# UNITED STATES PATENT AND TRADEMARK OFFICE

APPLICATION NO.	FILING DATE	FIRST NAMED INVENTOR	ATTORNEY DOCKET NO.	CONFIRMATION NO.
10/680,069	10/06/2003	Tuoc Tan Nguyen	816020-100050-US	9948
34026	7590	05/03/2005	EXAMINER	
JONES DAY 555 WEST FIFTH STREET, SUITE 4600 LOS ANGELES, CA 90013-1025			MILLER, CHERYL L	
			ART UNIT	PAPER NUMBER
			3738

# Office Action Summary

## DETAILED ACTION

Patent Application Publication Feb. 27, 2003 Sheet 2 of 13

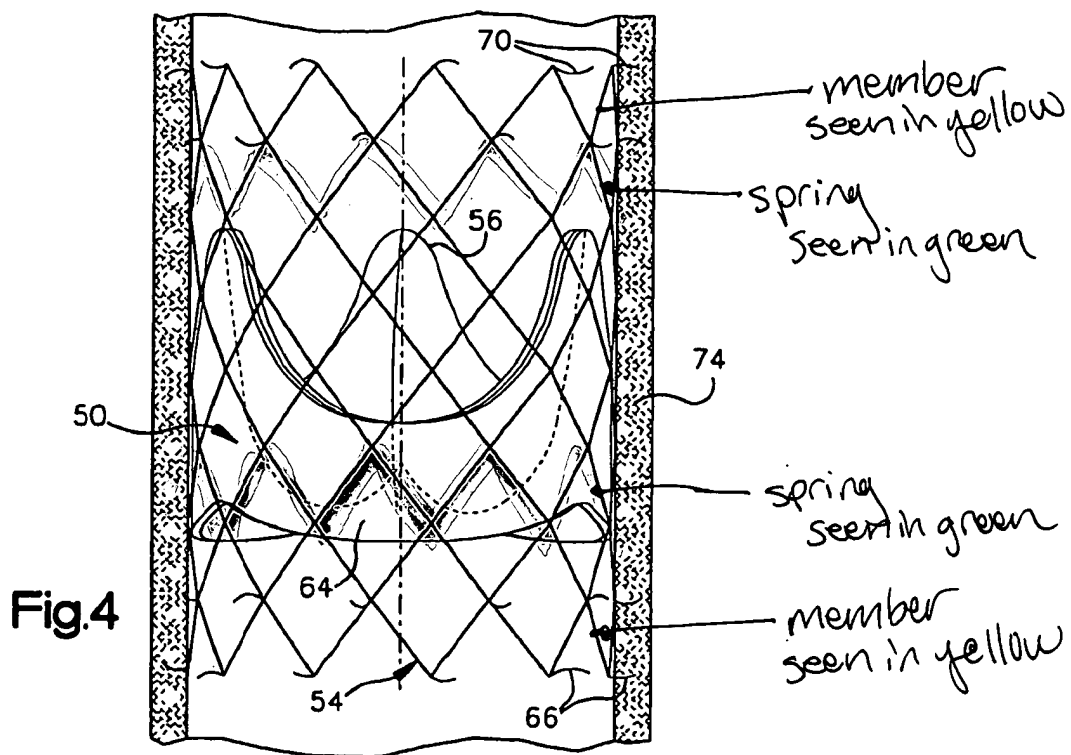
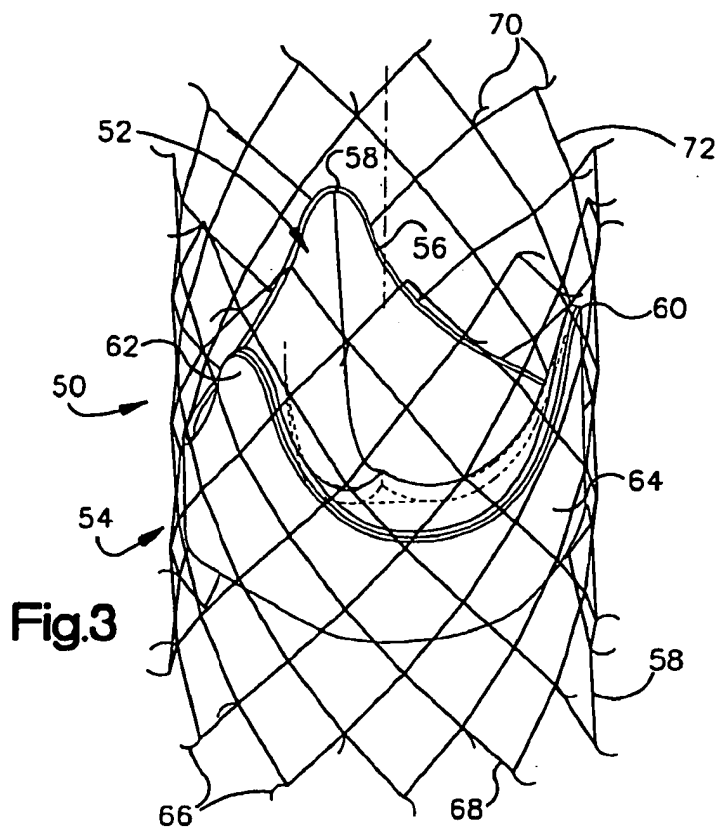
Claims 1-2 and 5-6 are rejected under 35 U.S.C. 102(e) as being anticipated by Gabbay (US 2003/0040792 A1). Gabbay discloses a valve assembly (fig.2, 4, 14) comprising a replacement valve (12, 52, 472) having a scalloped inflow annulus (seen as slightly scalloped in fig.4, 15, 24, 25; and disclosed to scallop, [0042]), an outflow annulus, and a plurality of leaflets (22, 24, 26), and a spring aided anchoring structure (14, 54, 420) comprising a plurality of members (members may be considered a ring strut seen in fig.4, attachment 1, or linear members 406, 428, seen in attachment 2) and a plurality of springs therebetween (springs may be considered to be ring stents positioned between end stents, seen in attachment 1, the stents having spring properties 0048, 0049; or spring coils 408, 430 in attachment 2). Gabbay discloses the valve (12, 52, 472) positioned internal of the anchoring structure (14, 54, 420). Gabbay discloses the members (struts in attachment 1 or 2) to comprise peaks and valleys. Gabbay discloses the assembly to comprise anchoring sections (this could be any portion along stent, or could be barb 66, or flare sections on stent).
